DEALER SERVICE BULLETIN

Number: DSB 13-0010

Title: Edge® Thermostat Mandatory Rework Program

Figure 1 – Typical schematic showing direct connection to indoor supply fan contactor coil (IFC)

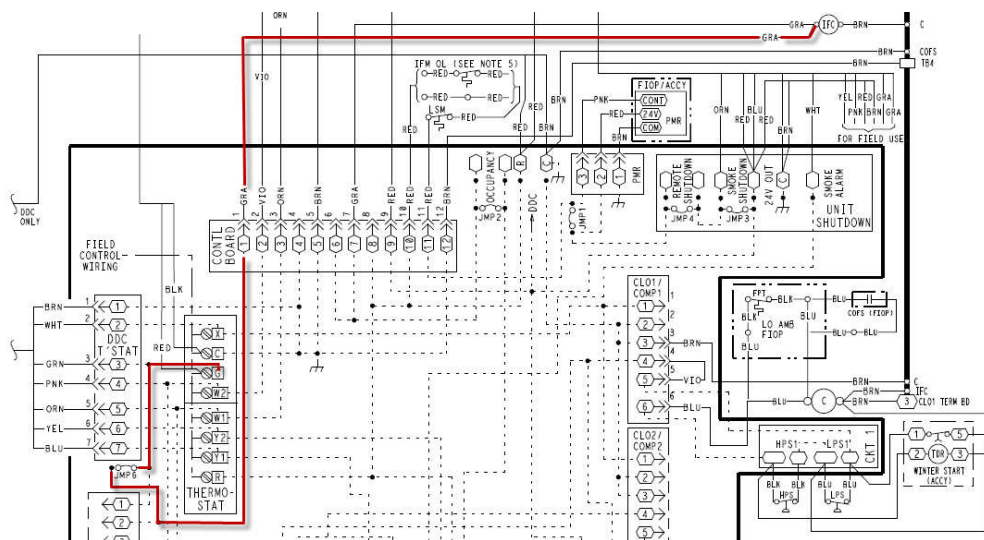
It has been determined that installation of the thermostat models subject to this bulletin (*model numbers noted above*), **only if attached directly to a supply fan electromagnetic contactor** may demonstrate overheating and /or smoking as the result of a cracked capacitor (see Figure 1 for example of this connection). The load introduced by the equipment contactor coil could fatigue this capacitor on the thermostat's **Equipment Control Module (ECM)** printed circuit board resulting in electrical overstress and excessive heat.

To avoid equipment failure and/or personal property damage the **Equipment Control Module (ECM)** portion of the thermostat must be replaced. Carrier has developed an ECM retrofit kit orderable on SAP to be implemented in installations identified above. The retrofit kit should be installed as outlined in Appendix A.

Factory-installed MOV

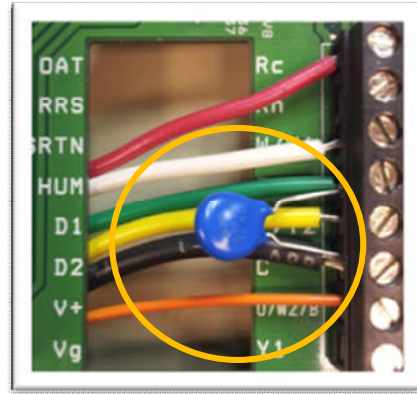
3. Install the ECM retrofit kit making sure the factory-installed Metal Oxide Varistor (MOV) supplied with the kit is securely attached to terminals 'G' and 'C' on the terminal block along with the required thermostat wires. See picture of kit as supplied and wired retrofit kit below.

4. Gently pull on the wire and each lead of the MOV and thermostat to verify the termination has captured both securely.
5. Return the removed ECM to Carrier following the steps outlined under the Field Action section of this bulletin
